Thank you for your July 15 letter requesting an interpretation of the background color and symbol used on the In-Street Pedestrian (R1-6 series) signs (Section 2B. 12 of the Manual on Uniform Traffic Control Devices (MUTCD)).

We appreciate the opportunity to provide the clarification. We have assigned the following official ruling number and title to the request: "7-65(I)—In-Street Pedestrian Sign Color & Symbol—UDOT." Please refer to this number in future correspondence. If you need further assistance, please contact Mr. Fred Ranck at 708-283-3545.

Re: Interpretation Request, In-Street Pedestrian Signs, R1-6 Series

R1-6

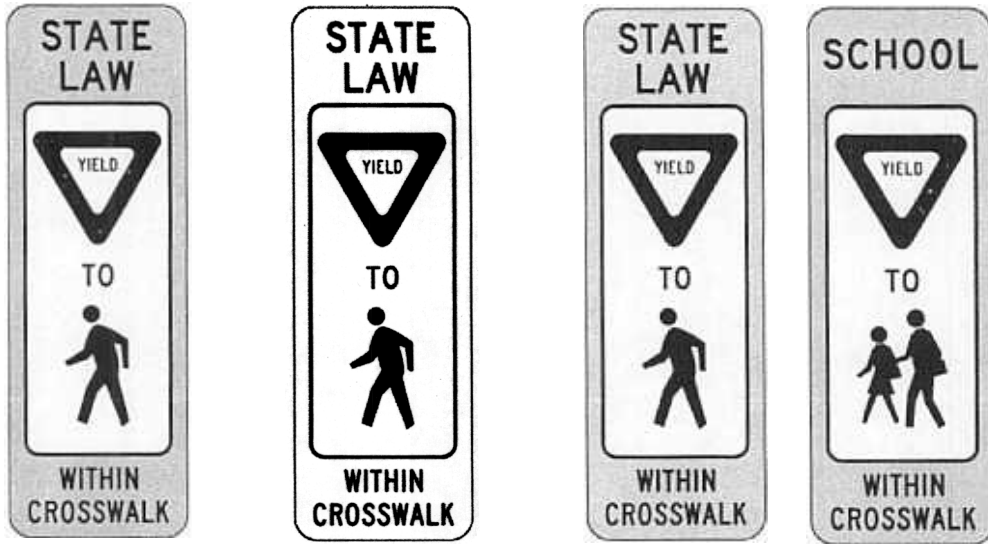
The Utah Department of Transportation (UDOT) is requesting an interpretation on the design of the In-Street Pedestrian Signs, R1-6 series. We have two issues for review: (1) the use of yellow for the background color; and (2) the use of the school pedestrian symbol.

The current edition of the MUTCD in Section 2B.12 states for the R1-6 series signs that: **"If used, the In-Street Pedestrian Crossing sign shall have a black legend (except for the red STOP or YIELD sign symbols) and border on either a white and/or fluorescent yellow-green background."** This not only dictates the use of the fluorescent yellow-green or white for this sign, but it precludes the use of the color yellow. Traditionally the color yellow has been the color for pedestrian signing, with the optional use of fluorescent yellow-green. We believe the use of yellow as a background color of the R1-6 series signs is in conformance with the intent of the Manual.

The text of Section 2B.12 does not dictate the type of symbol to be used on the R1-6 series. However, the drawing in Figure 2B-2 shows the use of the pedestrian symbol. We believe that the use of the school pedestrian symbol on the R1-6 sign is in conformance with the intent of the Manual. It would be a more consistent message for a motorist approaching a school crosswalk with the School Crosswalk assembly signs to see a R1-6 sign with a school pedestrian symbol, than to change the message at the point of conflict and show a pedestrian symbol. We would use the R1-6 sign with the school pedestrian symbol at a school crosswalk, and only at times when school children are present.

We request your interpretations on the use of (1) a yellow background and (2) the school pedestrian symbol on the R1-6 sign series.

When the In-Street Pedestrian Signs were developed, the fluorescent yellow-green was chosen for the added emphasis. We agree that yellow has historically been a pedestrian sign color; therefore using a yellow background on the In-Street Pedestrian Series signs is in conformance with the intent of the MUTCD. Furthermore, we are not aware of any research that shows that a yellow background for the In-Street Pedestrian is less safe than the fluorescent yellow-green background.

The second issue of your request deals with what symbol (Pedestrian or School Pedestrian) is used on the In-Street Pedestrian signs. You state that using the School Pedestrian symbol (S1-1) rather than the Pedestrian symbol shown on MUTCD Figure 2B-2 would give a more consistent message at a school crosswalk. We agree that the proposed use of the School Pedestrian Symbol on the In-Street Pedestrian sign at a school crosswalk is in conformance with the intent of the MUTCD.
